PCN# : P5ABAAB
Issue Date : Nov. 13, 2015

Information Only Notification

Figure 9. Maximum Safe Operating Area

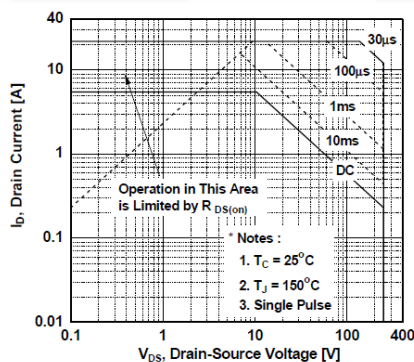
- 1) Drain-Source Diode Characteristics, $I_S = 5.5 \text{ A}$ (page 2)
- 2) Drain-Source Diode Characteristics, $I_{SM} = 20 \text{ A}$ (page 2)
- 3) Current Figure 9, Maximum Safe Operating Area (page 4)
- 4) Current Figure 10, Maximum Drain Current vs Case Temperature (page 4)

Figure 9. Maximum Safe Operating Area

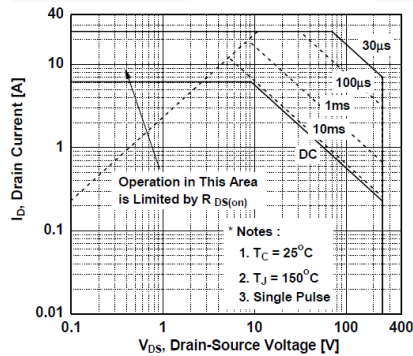
- 1) Drain-Source Diode Characteristics, $I_S = 6.2 \text{ A}$ (page 2)
- 2) Drain-Source Diode Characteristics, $I_{SM} = 25 \text{ A}$ (page 2)
- 3) Updated Figure 9, Maximum Safe Operating Area (page 4)

Maximum Drain Current values being updated to reflect max Z_{thjc} as opposed to measured Z_{thjc} , and reflected in updated figures 9 and 10.

Figure 10. Maximum Drain Current vs. Case Temperature

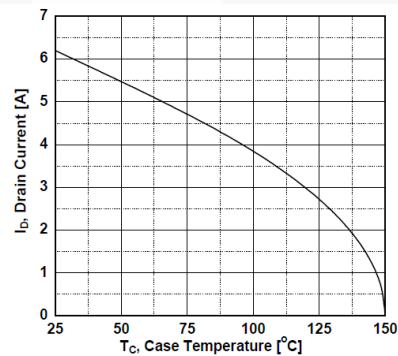
4) Updated Figure 10, Maximum Drain Current vs Case Temperature (page 4)
